Memorandum

Date: December 14, 2012

Re: Mixed Use Development at 321 Commercial Street; Level III Site Plan/Subdivision, J B Brown & Sons, Applicant.

Project #: 2012-615 **CBL:** 40-E-3

Foundry Lane looking toward Commercial St

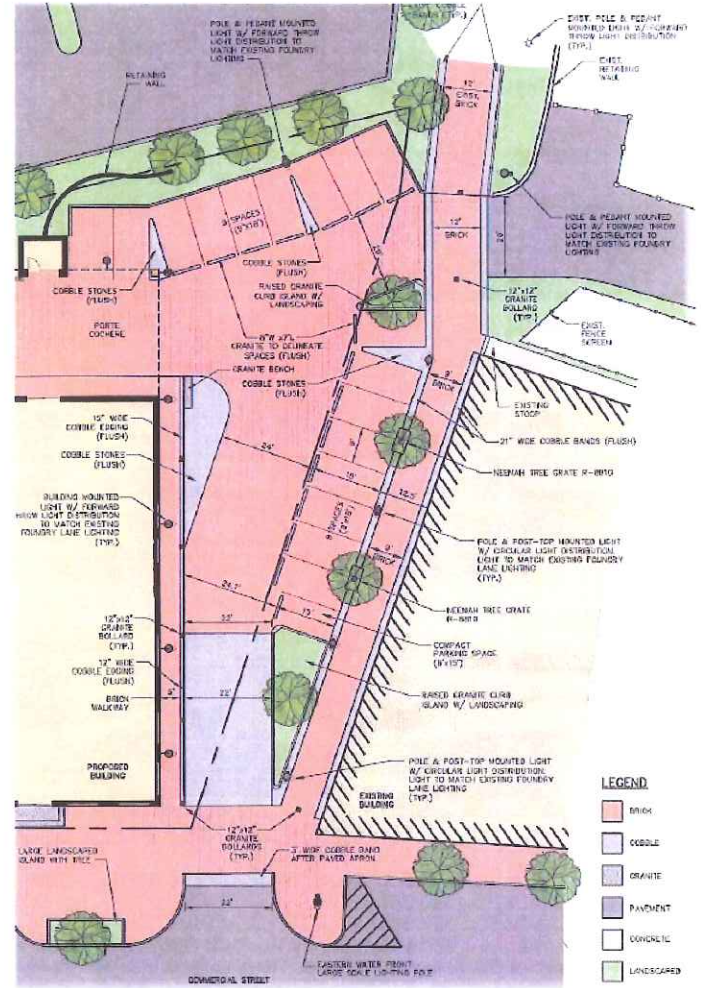
At the first workshop the proposal included bicycle parking and a bench where the existing path ended at the site boundary and added a 5 foot wide brick paved section extending to Commercial Street between the Baxter Building and the proposed parking spaces (Site Plan 6 and above left). At the workshop the Planning Board encouraged the applicant to more clearly continue the scale of the existing path to Commercial Street, based on the following concerns as outlined in the 11.13.2012 PB Memorandum:

- The Transportation reviewer comments: *The 11 parking spaces on the former Foundry Lane do not appear to meet City dimensional standards. A waiver will be required. I would also note that there is general concern about pedestrian accessibility in this area and modifications to the plan may be necessary (Attachment 7).*

Above: As proposed at the First PB Workshop

Above: Current proposal to address comments

At a follow-up meeting with the applicant to consider the above concerns/comments (also see Attachment P), the applicant proposed the layout shown on page 9, which incorporates a 9 foot wide brick path edged with cobbles and revised parking, planting and lighting. The consulting Traffic Engineer has confirmed (Attachment 15):

Status: The applicant has submitted a revised plan and the design details indicate waivers will be required. I support waivers from the City's Technical Standards given the desire to provide a dedicated pedestrian facility leading to York Street. I have reviewed the responses from the applicant on comments as it relates to the access to the compact vehicle parking space and a narrow aisle width. I find their responses to be reasonable and as noted above support waivers from City standards.
